# UNITED STATES PATENT AND TRADEMARK OFFICE

APPLICATION NO.	FILING DATE	FIRST NAMED INVENTOR	ATTORNEY DOCKET NO.	CONFIRMATION NO.
10/736,852	12/16/2003	Joseph J. Nahas	SC13123TC	6904
23125 7590 09/11/2007 FREESCALE SEMICONDUCTOR, INC. LAW DEPARTMENT 7700 WEST PARMER LANE MD:TX32/PL02 AUSTIN, TX 78729			EXAMINER LAMARRE, GUY J	
			ART UNIT 2112	PAPER NUMBER
			MAIL DATE 09/11/2007	DELIVERY MODE PAPER

### NON-FINAL OFFICE ACTION

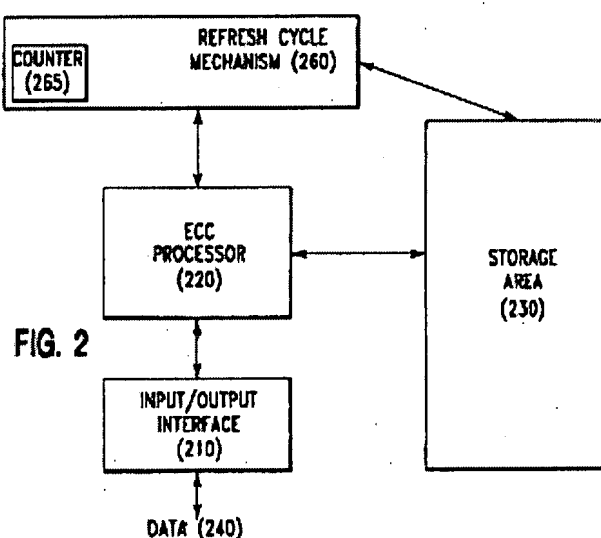
As per **Claims 1-27**, **DeBrosse et al.** anticipates the claimed invention because Fig. 2 depicts an error counter (block 265) for memory core (block 230) for logging errors occurring subsequent to detection/ECC (block 220) thereof via testing memory access through a magnetoresistive random access memory (MRAM) core, e.g., *'Counters can be used as well, as depicted in FIG. 2. For example, as shown in FIG. 2, the ECC processor (220) can update an error counter to cause the storage area to be refreshed after a particular number of errors has been detected, or, alternatively, when a particular number of errors has not been detected. In addition, there are intervals when no write operations are performed to a particular MRAM or sub-array of the MRAM, for example, when the storage area is either inactive or only read from*

Fig. 2 depicts memory access (block 210) comprising: a read operation, a compare operation, and a write operation, toggle operation effected in accordance with memory access cycle time.

As per Claims 1-2, 8-9, 18-19, DeBrosse et al. discloses, in Fig. 2, the claimed memory circuit, comprising: a magnetoresistive random access memory (MRAM) core for storing data received by the memory circuit and outputting stored data, the magnetoresistive random access memory (MRAM) having a reserved portion; an error correction code (ECC) coder for adding a redundancy code to the data for storing in the magnetoresistive random access memory (MRAM) core; an ECC (BLOCK 220) corrector, coupled to the magnetoresistive random access memory (MRAM) core, for performing an analysis of the stored data and the redundancy code to detect and correct errors in the stored data that is output by the magnetoresistive random access memory (MRAM) core and providing an error signal when an error is detected from the analysis; and an error counter, coupled to the ECC (BLOCK 220) corrector and the magnetoresistive

**As per Claim 3**, DeBrosse et al. discloses, in Fig. 2, the claimed memory circuit of claim 1, further comprising a write cycle counter (block 265) for providing a count of occurrences of writing data in the magnetoresistive random access memory (MRAM) core for storage in the reserved portion of the magnetoresistive random access memory (MRAM) core.

**As per Claim 4**, DeBrosse et al. discloses, in Fig. 2, the claimed memory circuit of claim 3, further comprising a read cycle counter (block 265) for providing a count (block 265) of occurrences of reading data from the magnetoresistive random access memory (MRAM) core for storage in the reserved portion of the magnetoresistive random access memory (MRAM) core.

**As per Claim 7**, DeBrosse et al. discloses, in Fig. 2, the claimed memory circuit of claim 6, wherein the control means causes performance of a read operation (block 210), a compare operation (block 210), and a toggle operation (block 210) to perform a write cycle.

**Figure 1**

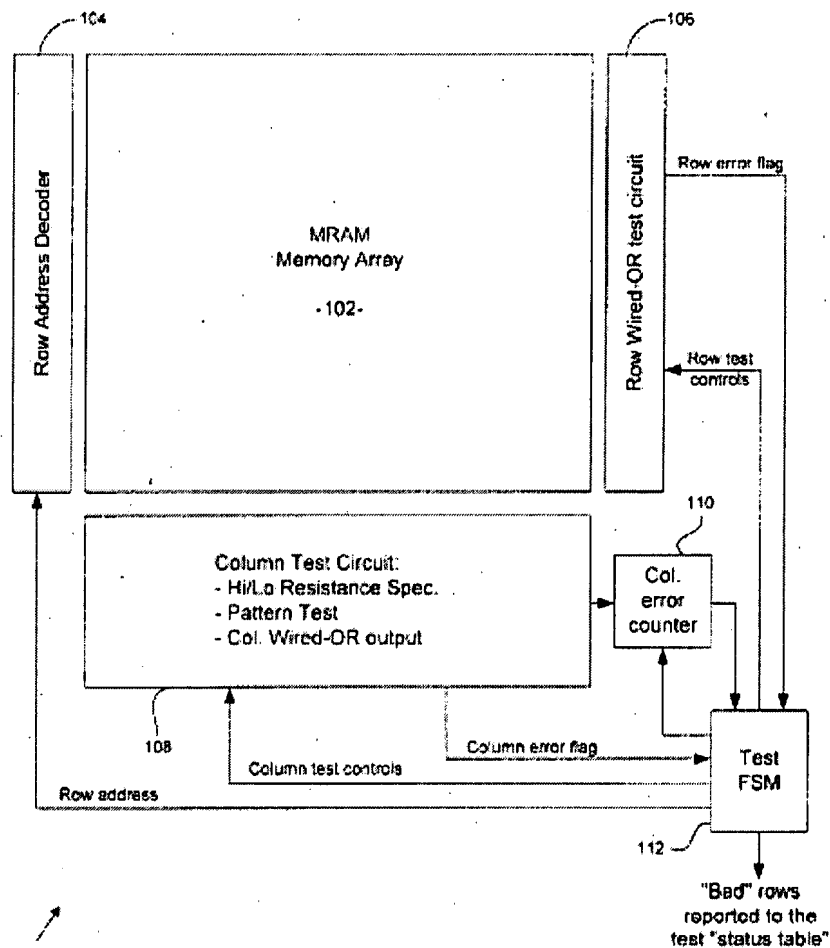
**As per Claims 1-2, 8-9, 18-19, Perner et al.** anticipates the claimed invention because Fig. 1 depicts an error counter (e.g., block 101) for memory core (block 102) for logging/marking errors occurring subsequent to detection/ECC (e.g., block 108) thereof via testing memory access through a magnetoresistive random access memory (MRAM) core, e.g., *'Errors reported by the column test circuits may be single bit errors that are correctable by ECC (Error Correction Circuits) or may be multiple bit errors that warrant the row being marked as a 'BAD' row. A counter is used to determine whether there are a sufficient number of errors for marking the row 'BAD'. If the column error flag indicates an error condition exists, the data in the sense amplifier data I/O scan registers is shifted into the column error counter (110 in FIG. 1). When the row error count exceeds a value determined as un-correctable by an external ECC, the row may be marked as 'BAD'. Error data created by the built-in self test circuits may be collected by external circuits for future processing or reported to the tester. One external circuit*

Fig. 1 depicts memory access (row/column address) comprising: a read operation, a compare operation, and a write operation, toggle operation effected in accordance with memory access cycle time.

As per Claims 1-2, 8-9, 18-19, Perner et al. discloses, in Fig. 1, the claimed memory circuit, comprising: a magnetoresistive random access memory (MRAM) core for storing data received by the memory circuit and outputting stored data, the magnetoresistive random access memory (MRAM) having a reserved portion; an error correction code (e.g., block 108) coder for adding a redundancy code to the data for storing in the magnetoresistive random access memory (MRAM) core; an ECC (e.g., block 108) corrector, coupled to the magnetoresistive random access memory (MRAM) core, for performing an analysis of the stored data and the redundancy code to detect and correct errors in the stored data that is output by the

magnetoresistive random access memory (MRAM) core and providing an error signal when an error is detected from the analysis; and an error counter, coupled to the ECC (e.g., block 108) corrector and the magnetoresistive random access memory (MRAM) core, for providing a count of occurrences of the error signal for storage in the reserved portion of the magnetoresistive random access memory (MRAM) core
